# Parkside Yeronga

## Conceptual Engineering Services Report

## 1.1 Further Issues Response

The Applicant received a Further Issues Letter from Economic Development Queensland Development Assessment dated 26 October 2021. This report has been revised to reflect the items raised. Specifically:

Drawing No.  
**CI-650-P01**

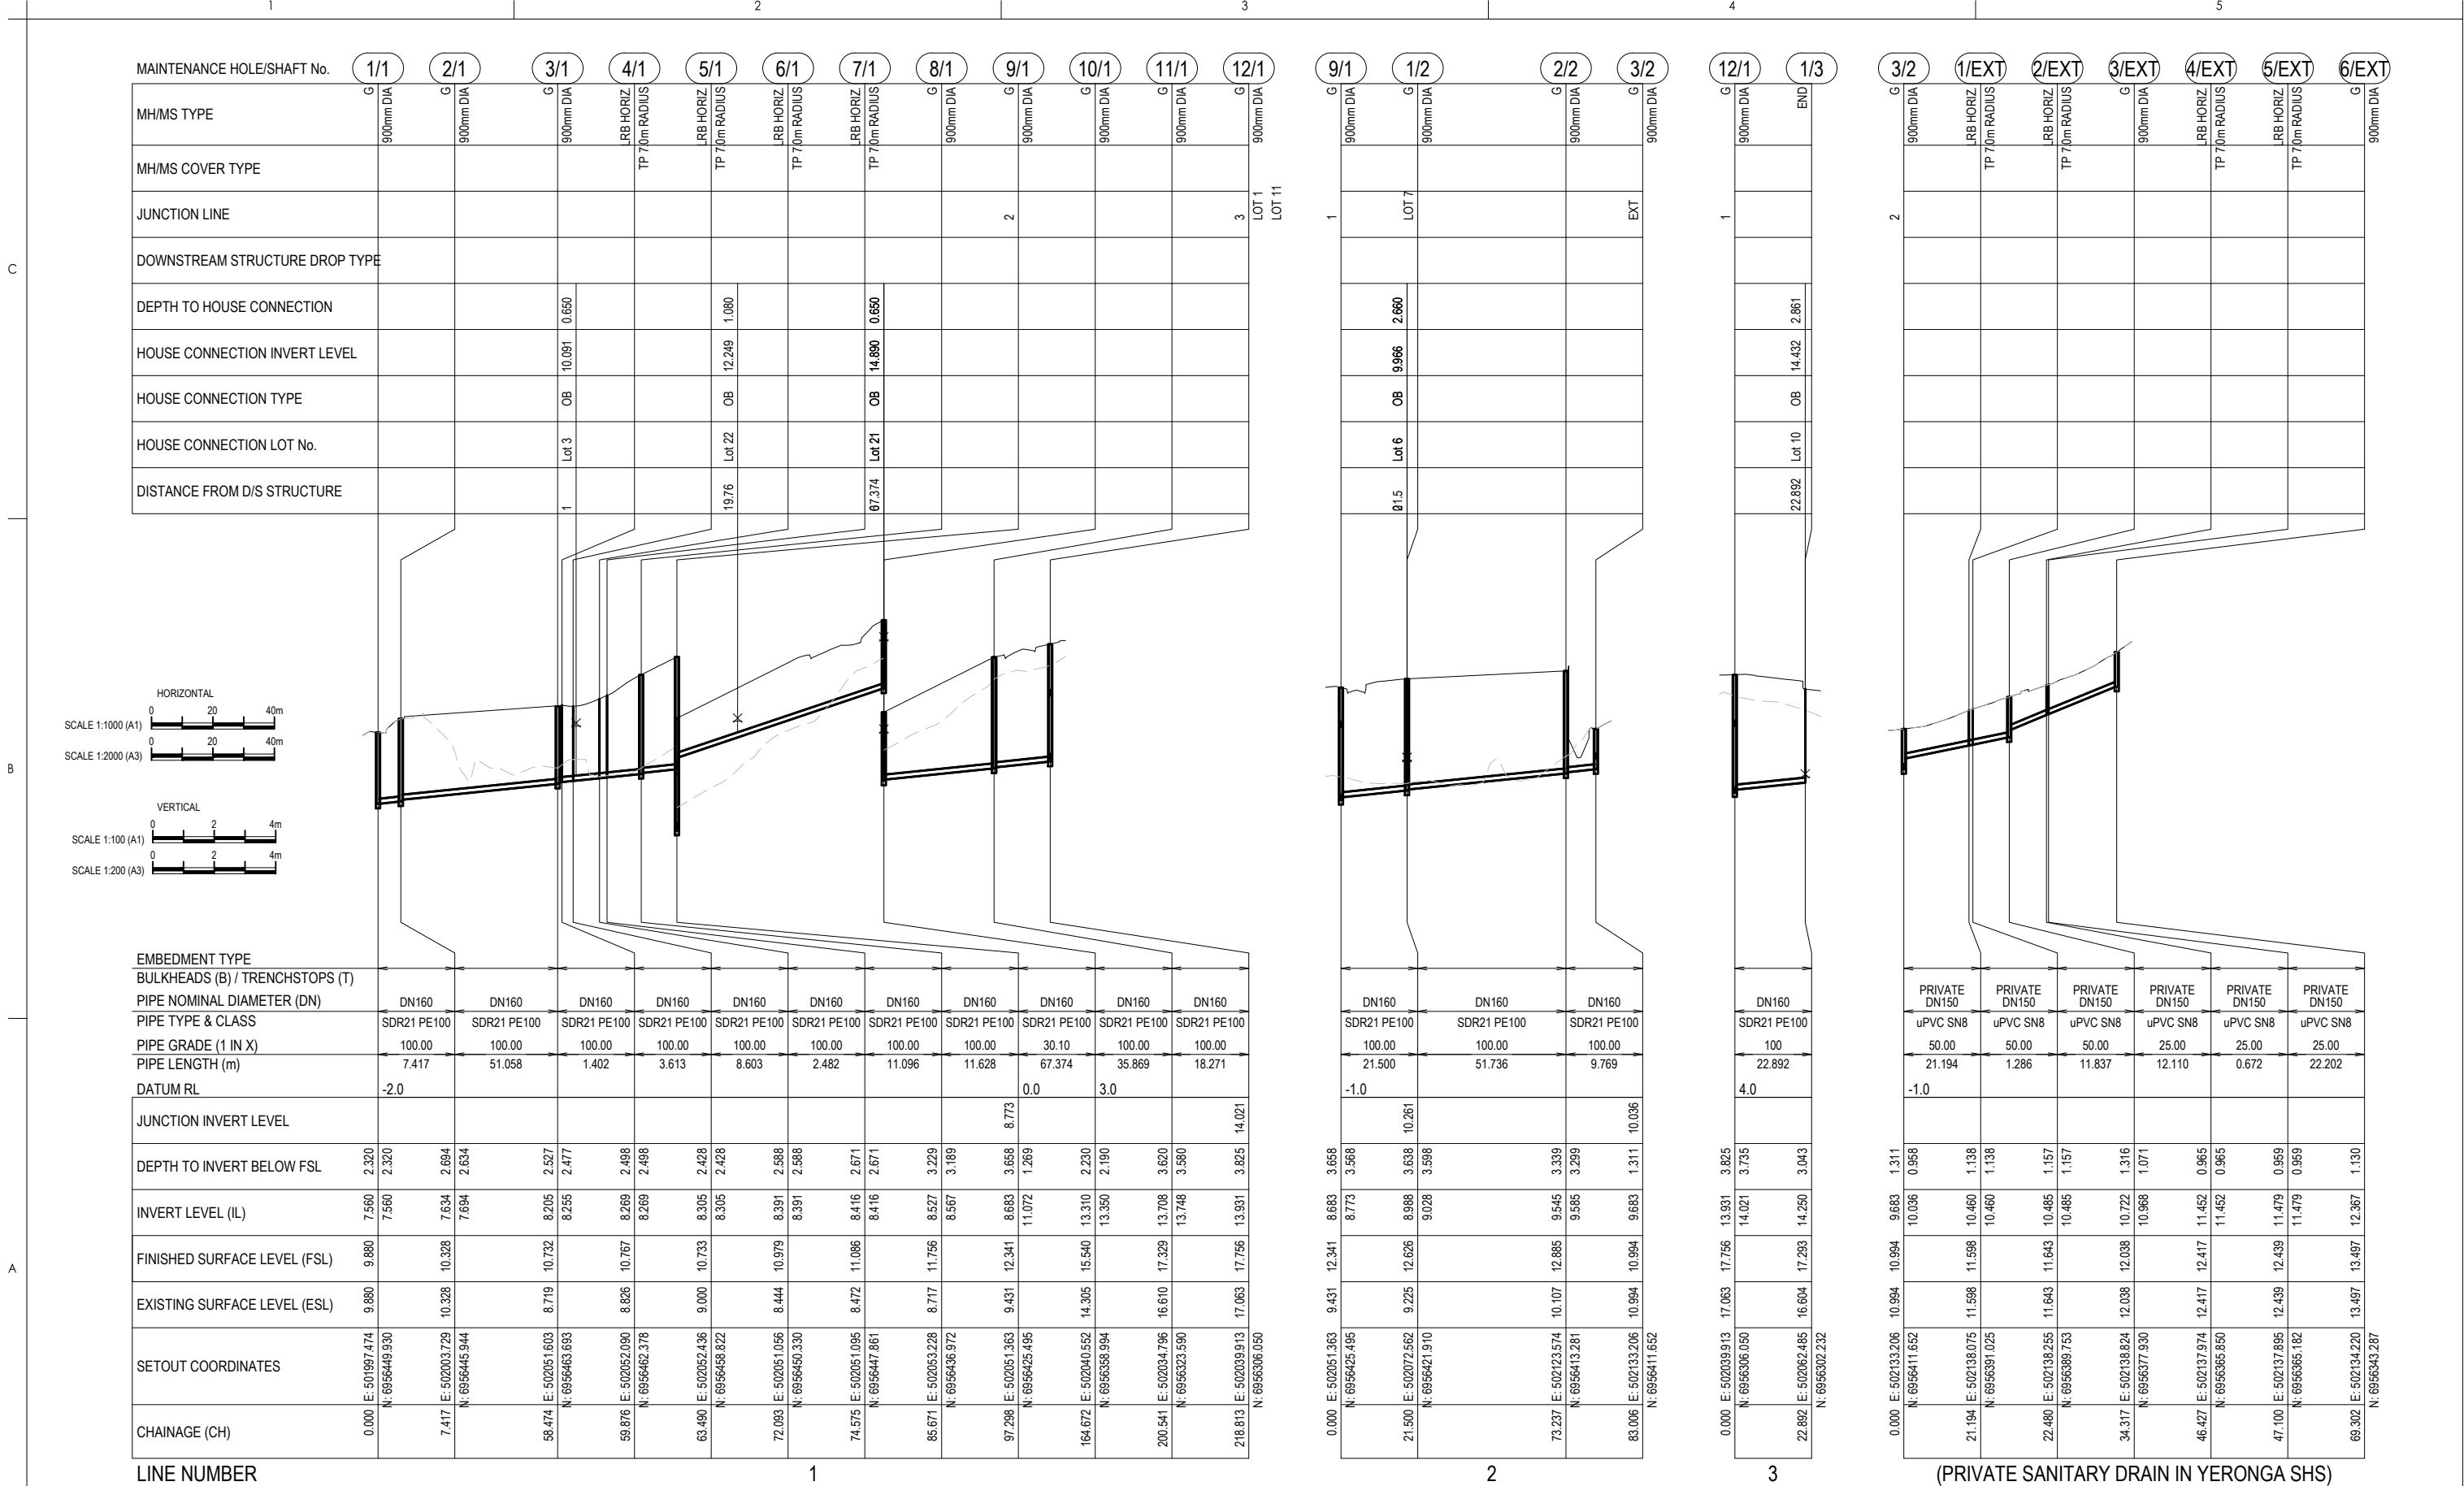
**Item 4g** - *The Combined Service Plan – Conceptual Master plan, drawing number CI-700-P02, rev A, prepared by Stantec, dated 15 September 2021, shows a water reticulation section through Lot 1 to service Lot 11 which is not acceptable. Amend the services plan to remove the section of the water main shown within Lot 1.*

A new water reticulation network is proposed within the proposed development to supply each of the proposed parcels as illustrated in drawing CI-700-P01 in Appendix D. It will be designed and constructed in accordance the SEQCode and dedicated to UU. It is proposed to be a DN180 PE water main, with associated hydrants, scours and isolation valves as necessary. Two connections to the external network in Park Rd are proposed to provide the required redundancy.
